Supplemental Information for West Shore Landing Apartments Preliminary Development Review

RE: Development Review Application, West Shore Landing Apartments (North River Rd.)
Tax Map 27, Lot 101

[SWI Replies to comments/questions are in blue - November 15, 2019](#)

Figure 2: Subject Parcel (Shoreland Zone)

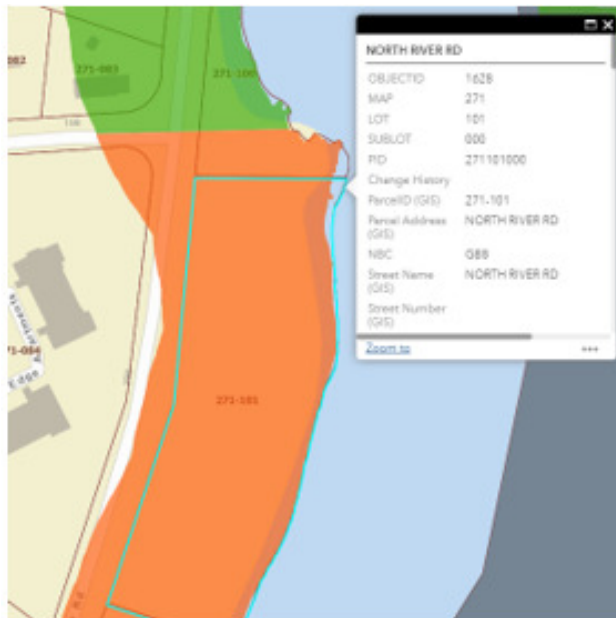
The orange area on the map to the left (Figure 2) is the General Development Shoreland Zone area.

- Per Subsection (a): General Development areas require a 25-foot setback from the normal high-water line. *The buildings are located outside of the 25-Foot setback from the normal high-water line. For clarification purposes, Planning Staff would recommend delineating the 25-foot setback and normal high-water line on the final plan.*

Our limit of disturbance to the river is defined as a 25' setback from the top of bank OR the edge of the floodway, whichever is first. This line is shown on both the Existing Conditions Plan and

the Sketch Plan as a setback linetype. I will insure that this buffer line is more visible on our November 18 submission plans. Please see the attached Sketch Plan for a depiction of the leading edge of this buffer.

Figure 3: Subject Parcel (Floodplain)

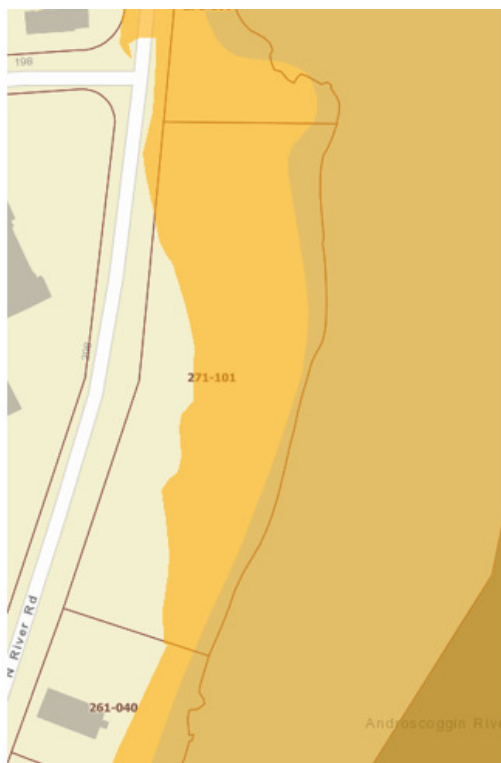
Per Subsection (c): The lowest floor elevation or openings of all buildings and structures need to be elevated in accordance with the floodplain overlay. *The floodplain regulations require buildings located in the AE floodplain (yellow area on map to the left in Figure 3) be elevated 1 foot above the base flood elevation (BFE). The BFE is 176.80 feet, the buildings are proposed to have a finished floor elevation (FFE) of 185 feet.*

Figure 4: Subject Parcel (Comprehensive Plan Designation)

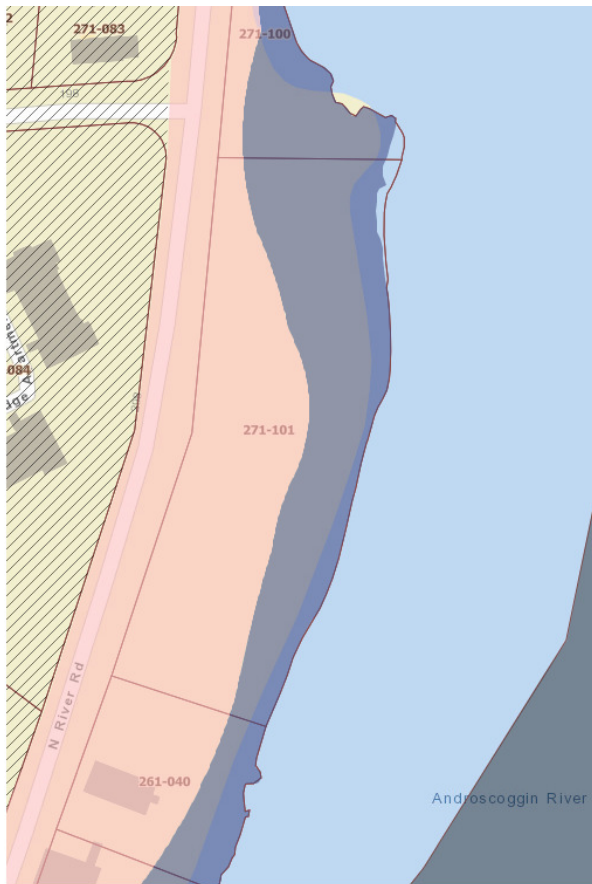
- g. The Planning Board had questions about how the buildings will be sited in relation to the Future Land Use Map. For example, will any of the structures be located in the Resource Protection area as designated by the Comprehensive Plan Future Land Use Map?

Please see the attached Exhibit 3C. Please note that the Future Land Use Map conflicts with the current General Business District zone for this area. As stated in the Comprehensive Plan, "...the RP District on the Future Land Use Plan map is only conceptual,".
